Pulaski County Schools
Energy Savings and Performance Contract
Addendum #2
March 25th, 2022

CMTA Contact:	Megan Brangers
Email:	MBrangers@cmta.com
Cell Phone:	502-919-1521

The following information supersedes or is in addition to information released in the Contract Documents dated March 11th, 2022 and addendum 1 dated March 18th, 2022.

E4-3.1B

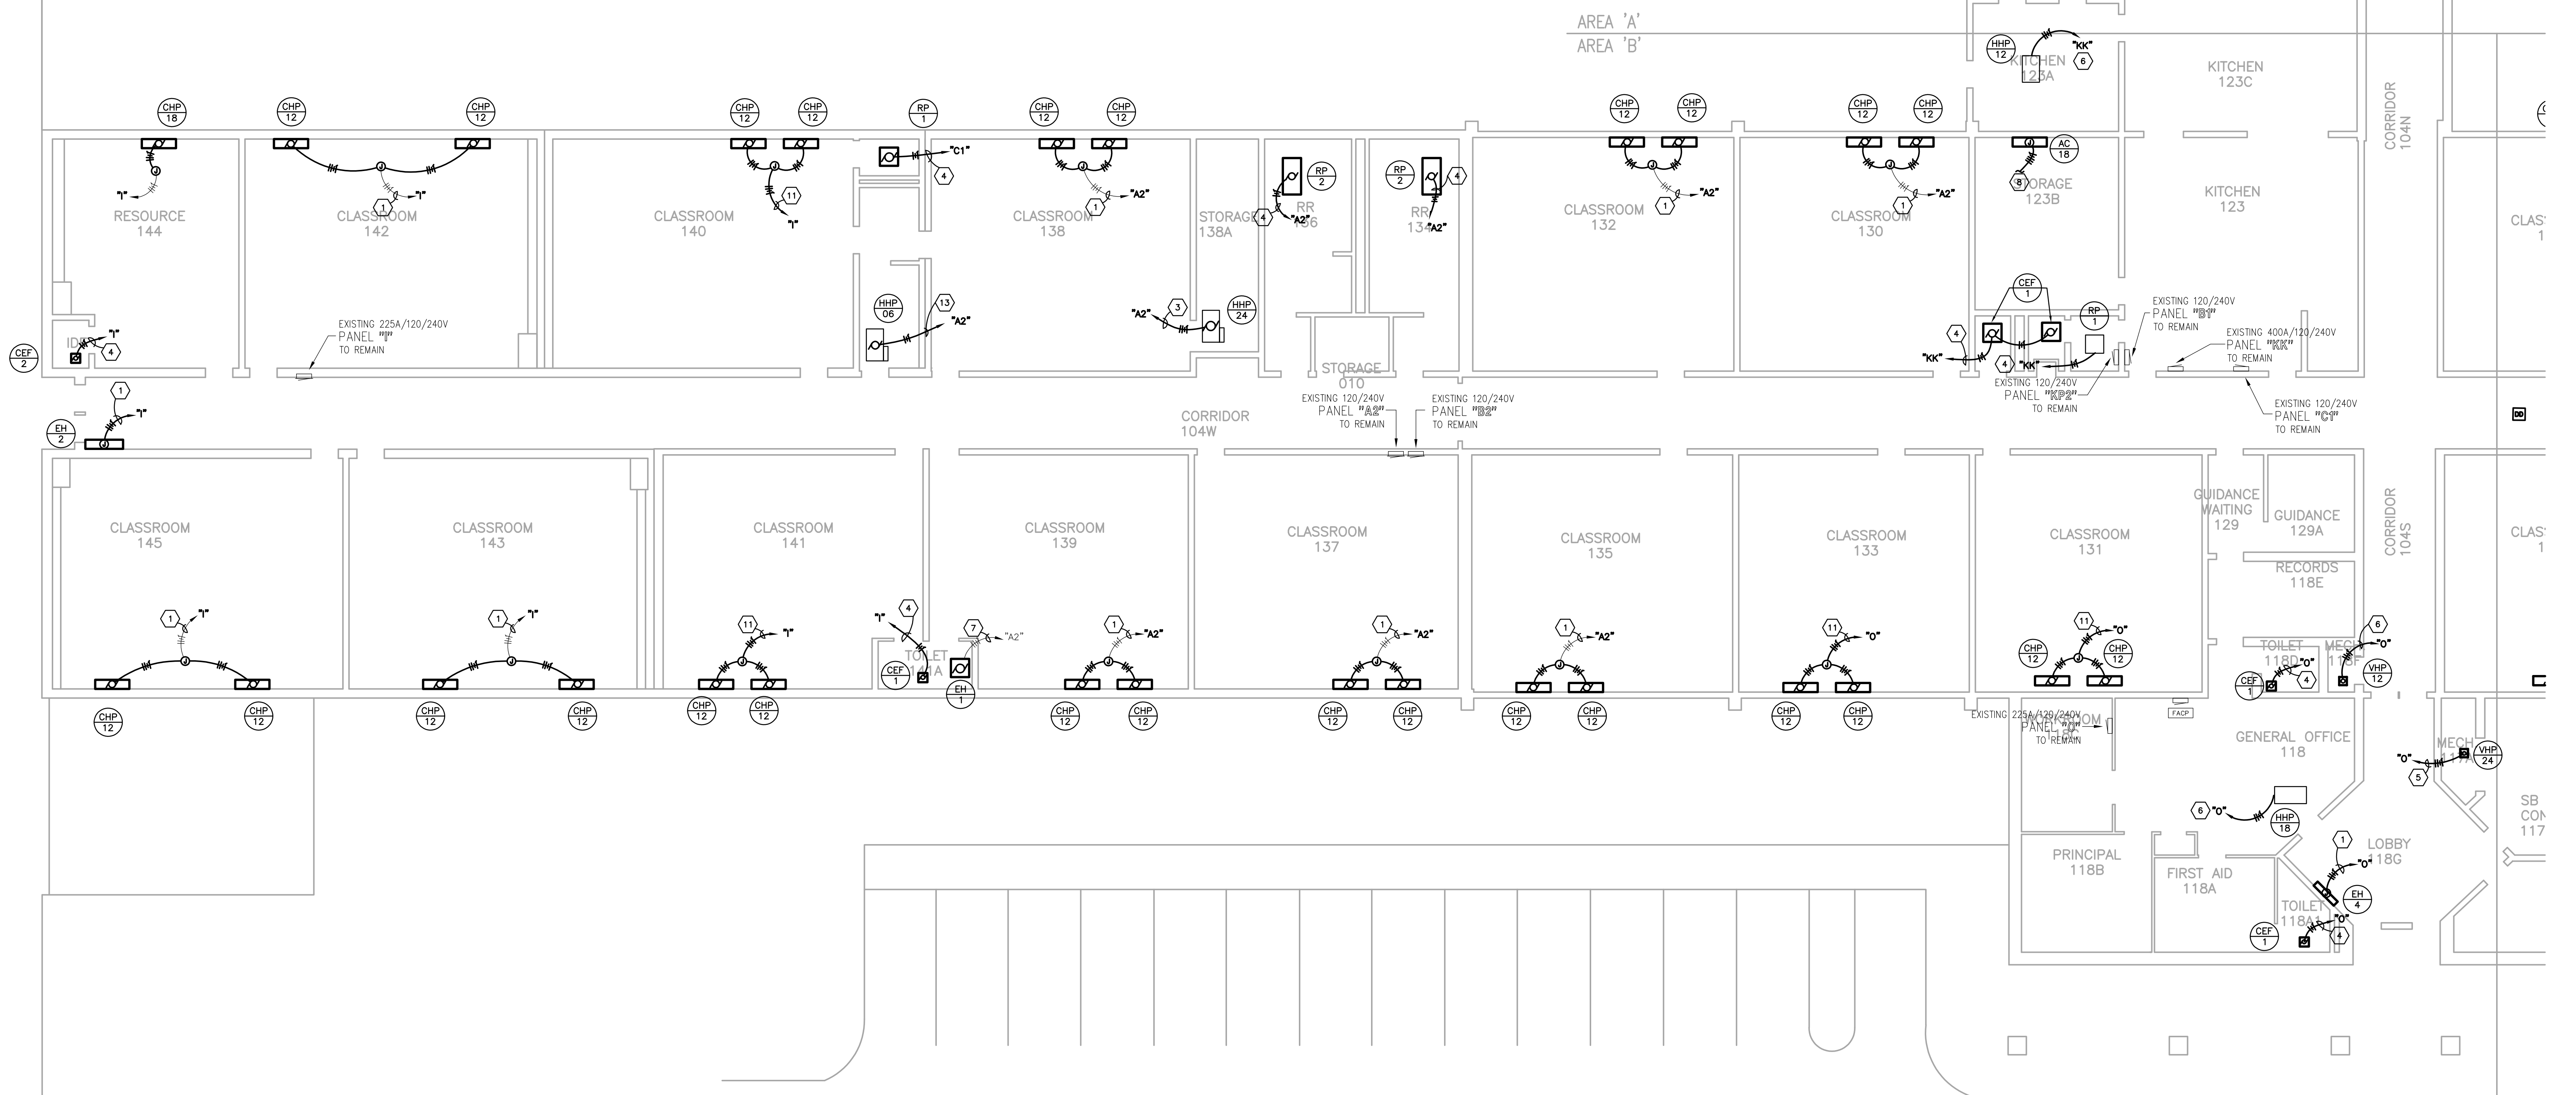
12. Drawings E4-3.1B
 - a. Clarification: Contractor to field verify panels serving existing terminal (CHP) units in classrooms and replace breakers in those panels per tag note 1 as required for replacement equipment.
